*MEMORANDUM*

DATE: May 1, 2018

TO: ISC/IO/PSL team  
 FROM: Daniel Sigg  
 SUBJECT: Modifications to the location of the EOM drivers  
 Refer to: LIGO-T1800196-v1

**Figure 1: Bottom of PSL-R2 Rack**

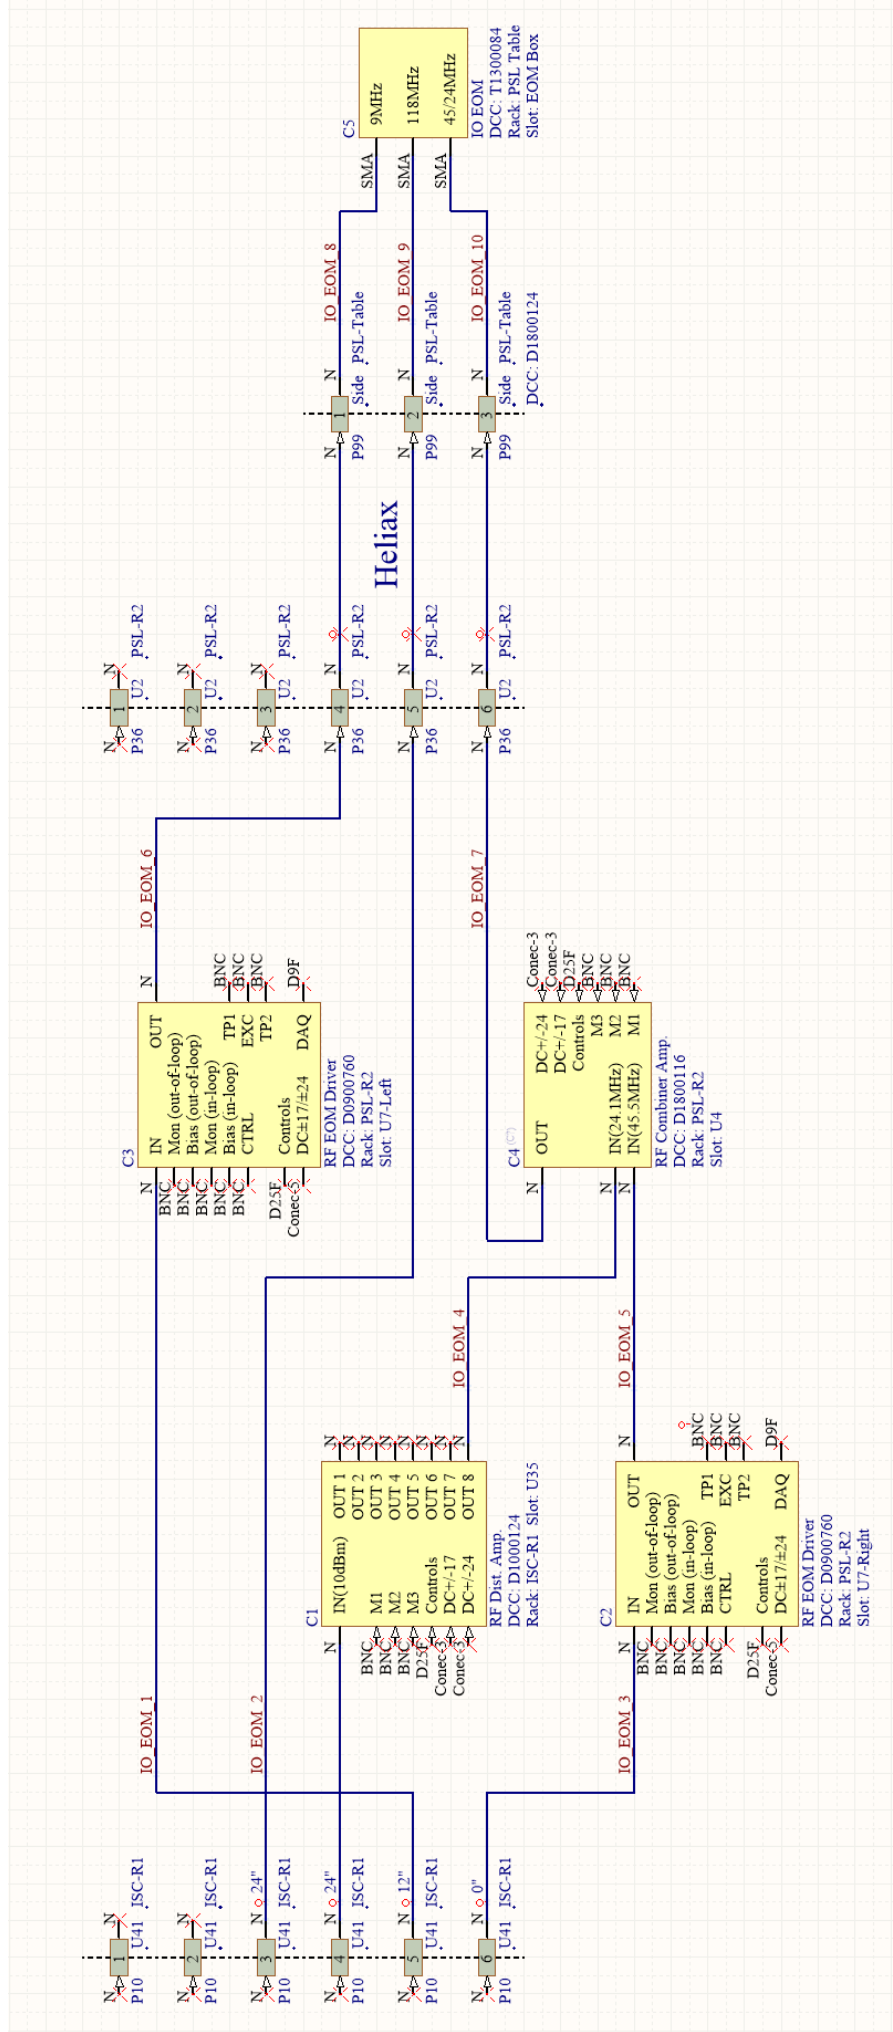
We will take this opportunity to make the LHO setup the same as the LLO one, by moving the EOM driver electronics outside the PSL enclosure. We use an 8U space at the bottom of the PSL-R1 rack to install a RF patch panel, [D1101479](#), the RF combiner/amplifier and the 2 EOM drivers for 9.1 and 45.5 MHz, [D0900760](#).
